# **3 Volt Intel<sup>®</sup> Advanced+ Boot Block Flash Memory**

**28F800C3, 28F160C3, 28F320C3, 28F640C3**

**Specification Update**

Order Number: 297938-014

### 2. 28F320C3xC Reset Failure

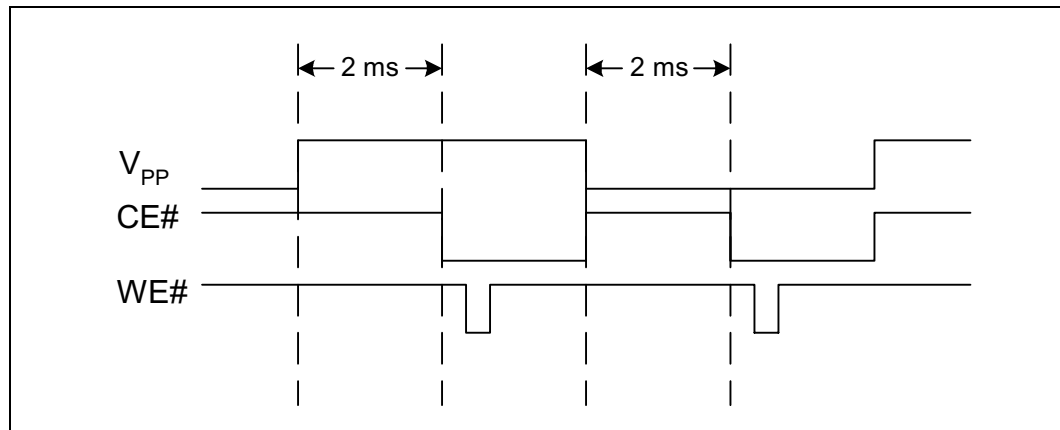
**Problem:** The 0.18 $\mu$ m 28F320C3xC devices can unintentionally reset under certain conditions where  $V_{PP}$  toggles.

**Implication:** When the reset occurs, any command being executed is interrupted and the flash switches to read array mode.

**Workaround:** There are four workarounds for this erratum:

- 1) Tie  $V_{PP}$  to  $V_{CC}$ ;
- 2) If the third and fourth digits on the top side FPO mark (third line) is equal or greater than “23”, then  $V_{CC}$  may be set from 2.7v to 3.3v.  $V_{CC}$  must not exceed 3.3v
- 3) Set  $V_{PP}$  to a static high or static low level as shown here; and

4) Wait 2 ms after a  $V_{PP}$  transition to access the flash device, as shown here.

Figure 1. Workaround Placement

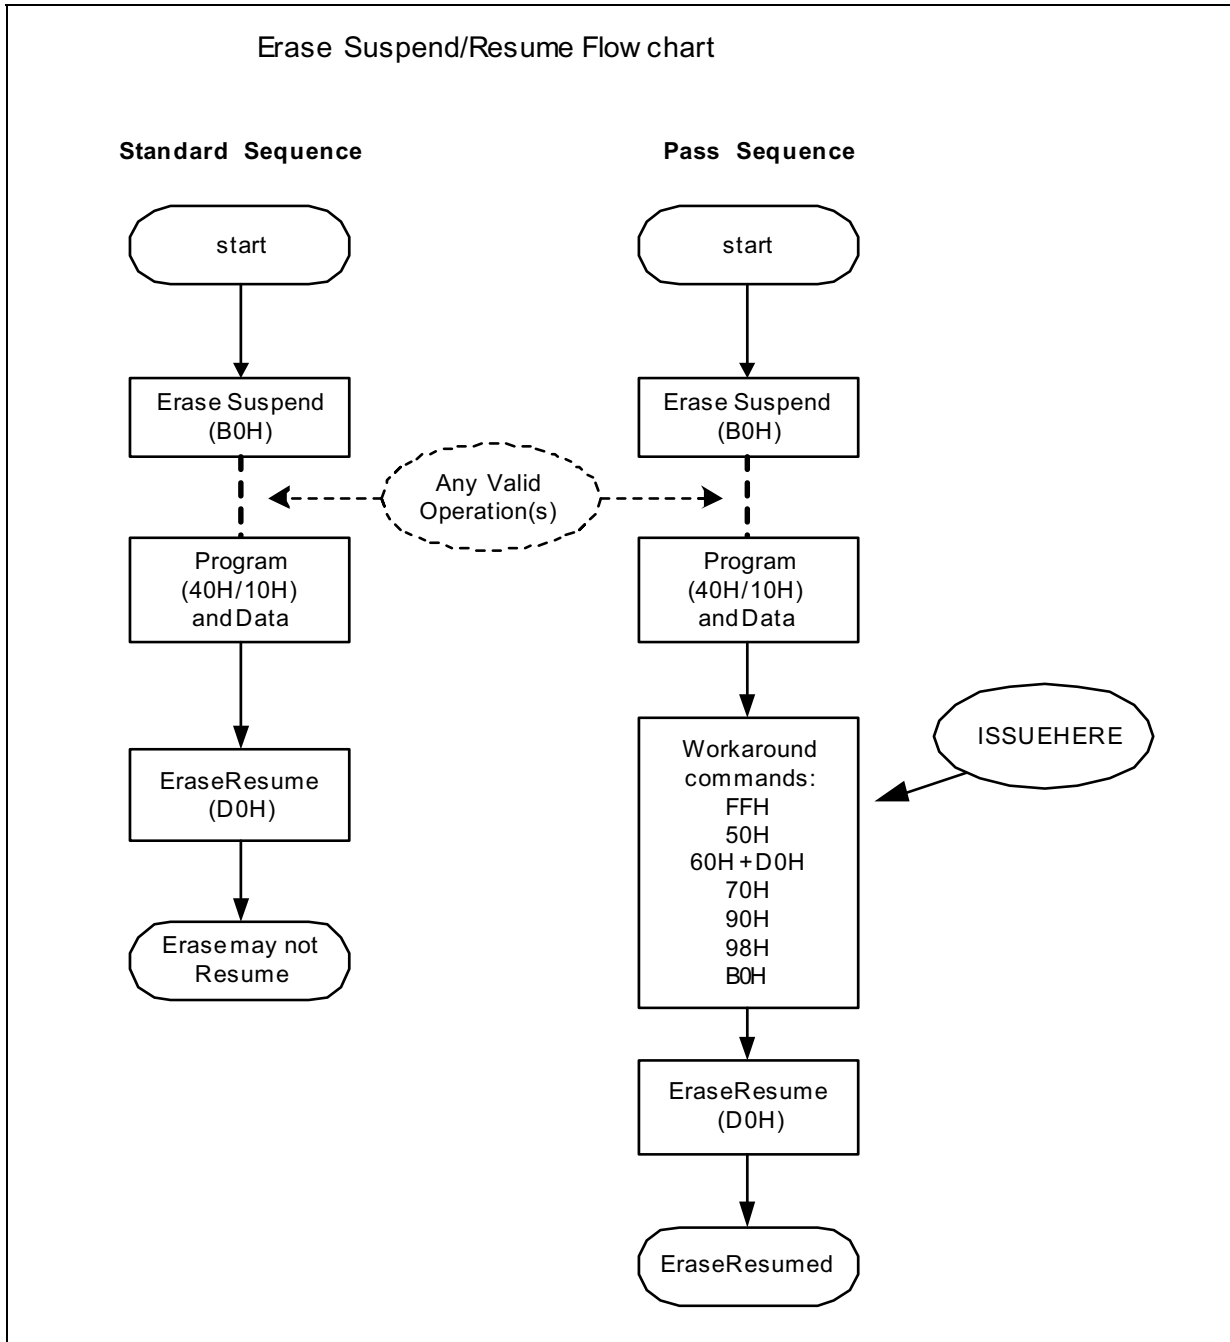
**Problem:** On the 0.18 $\mu$ m 28F160C3xC devices, a design anomaly was discovered. During an Erase-Suspend operation, if the Program (40H/10H) sequence is executed, under limited conditions the proceeding Erase Resume command (D0H) may not actually resume the device. No customers have reported failures in product applications. Customers who use any version of FDI (Intel Flash Data Integrator) software will not see this issue. If the Read Array command is issued prior to the Erase Resume command, users will not see the issue (typical in XIP applications).

**Implication:** The Resume Command (D0H) may be ignored by the device and will not correctly resume. The device will appear to remain in suspend (via status register). After a reset of the flash device the status register will clear. This failure has been recreated in a lab environment only.

1. If FDI (Intel Flash Data Integrator) software is used, users will not see the issue.
2. During an Erase-Suspend (B0H), user must issue any of the following commands after issuing the Program (40H/10H) and data sequence but before issuing the Erase-Resume (D0H) command.

## 5. 28F160C3xC and 28F640C3xC Lock/Unlock/Lock-Down Operation

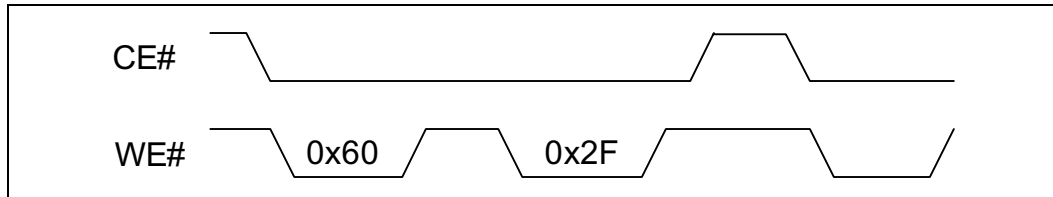
**Problem:** On the 16Mb and 64Mb 0.18 $\mu$ m devices, if CE# is deasserted after any block lock operation and before the next write sequence, the part may perform the same operation on additional blocks. (See waveform below.)

**Implication:** When CE# is deasserted after performing a block lock operation to a specific block and prior to the next write sequence, other blocks may perform the same operation.

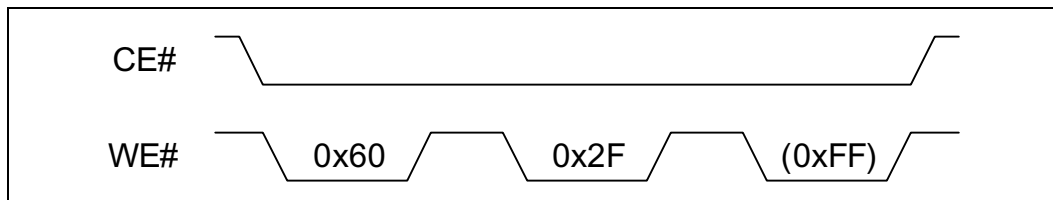
Immediately after performing a block lock, unlock, or lock-down operation, perform a valid write sequence before chip enable (CE#) is deasserted.

- 1) Assert CE# and toggle WE# to write the block lock setup command (0x60).
- 2) Toggle WE# a second time to write the confirm command (lock = 0x01; unlock = 0xD0; lock-down = 0x2F).
- 3) Toggle WE# a third time (ex: 0xFF- Read Array) before CE# is deasserted. (See waveform below.) Any other valid write sequence will also work (i.e., 0x90 - Read Configuration, 0x40 - Program, 0x20 - Erase).
